Supplemental Testimony of Westchester County Deputy Commissioner
of Transportation, Raymond S. Jurkowski, on the Evacuation Plan
for Indian Point

PROPOSAL TO PROVIDE
WESTCHESTER COUNTY
DEPARTMENT OF TRANSPORTATION
WITH AN EVACUATION MANAGEMENT SYSTEM

General Population Evacuation Route No.100

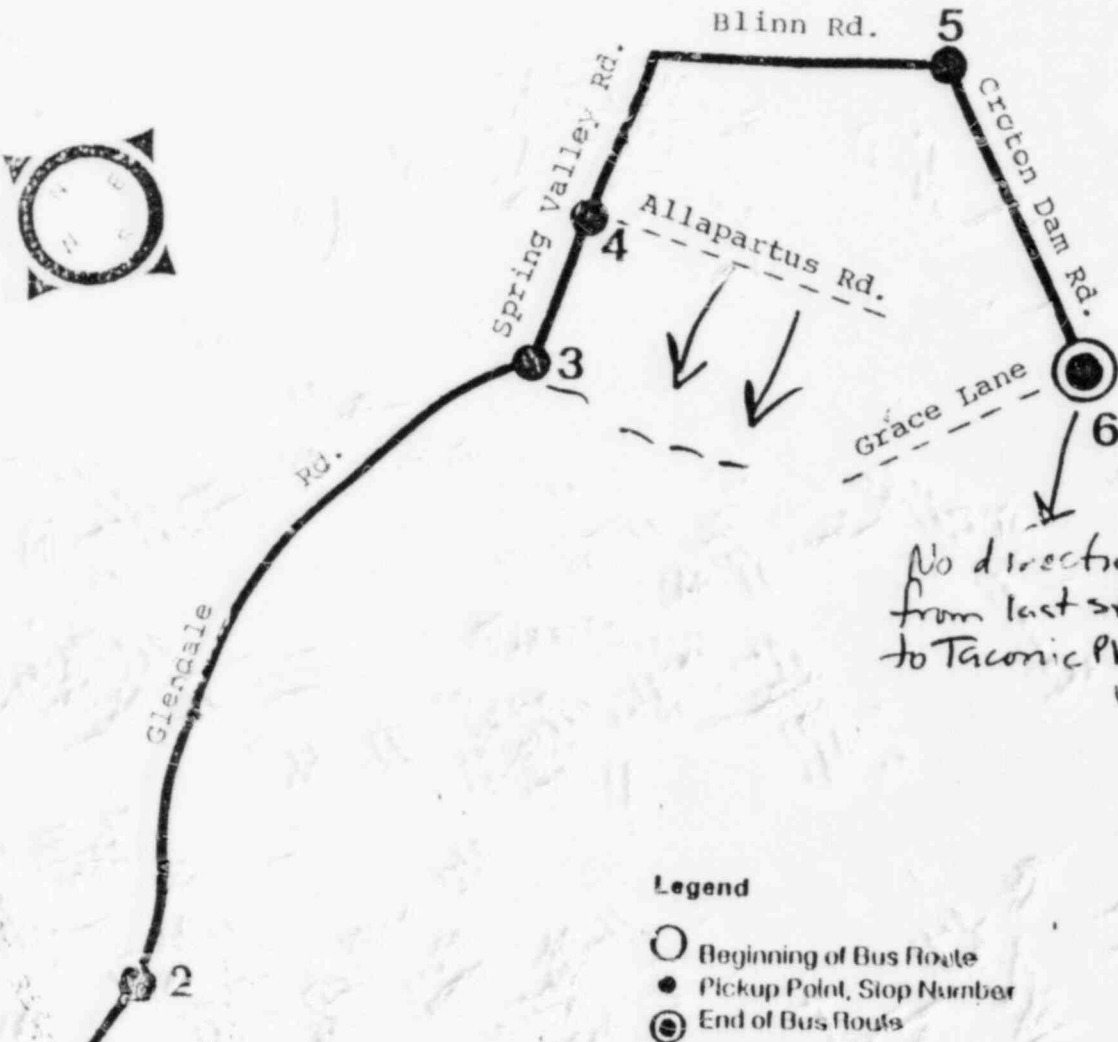
We also anticipate complications arising from the Guardsmen's unfamiliarity with local roads and conditions. This situation is further compounded by the facts that we still do not have satisfactory bus route maps, that not all the required bus movements have been mapped and that not all evacuation routes have been verified as to their suitability for bus operations (See Attachment 2 for a sample route map and Attachment 3 for a typical example of required bus movements.)

Vehicles By Company/Garage Site

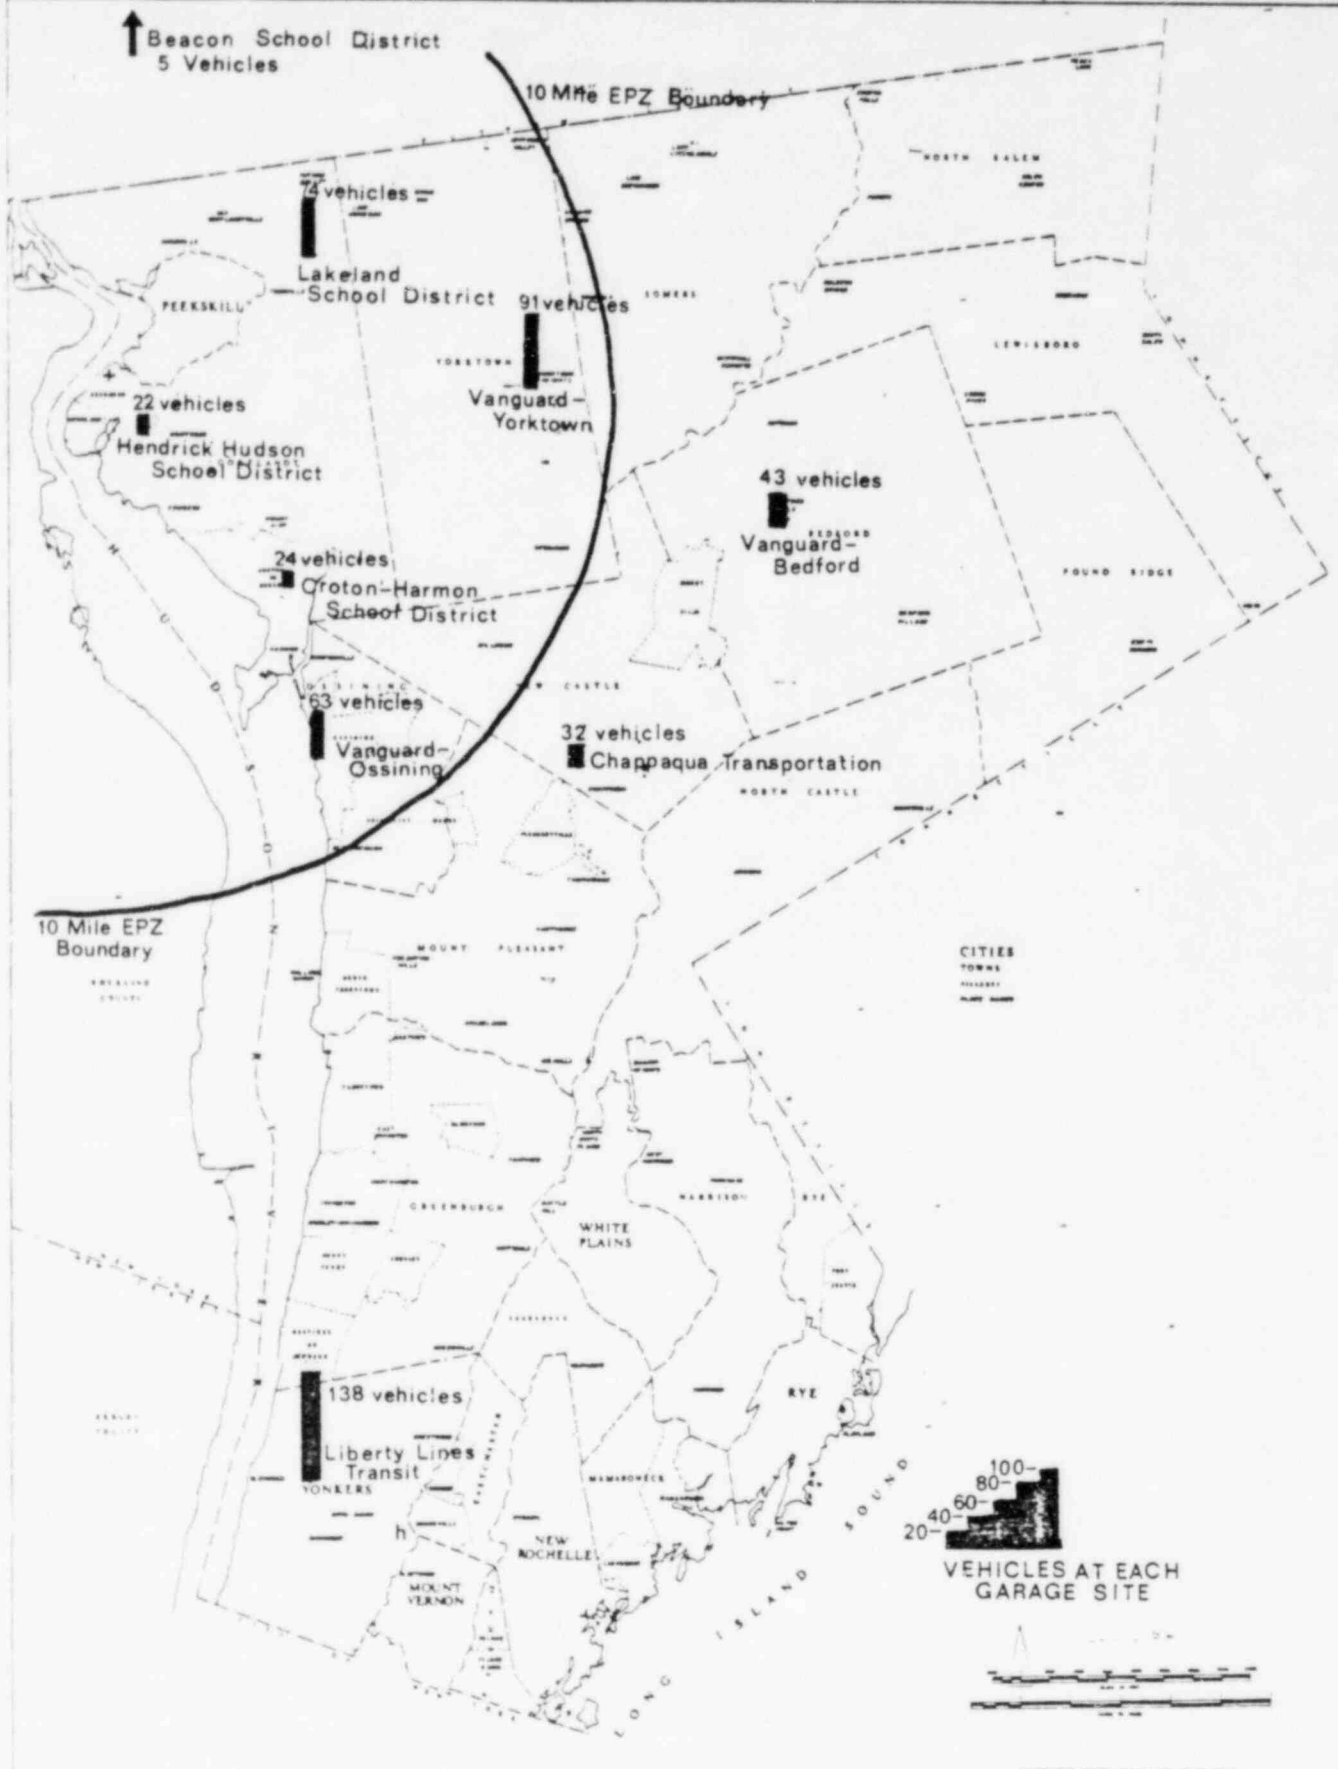
Under the current plan, five of nine bus garages are located within the area to be evacuated (See Attachment 6). Unless satellite base stations are identified outside the EPZ so that communications can be maintained, dispatchers and other essential personnel will be forced to remain in an evacuation zone for extended periods of time to direct the operation of their drivers during the evacuation and continuing through the reunion of family members at reception or congregate care centers.
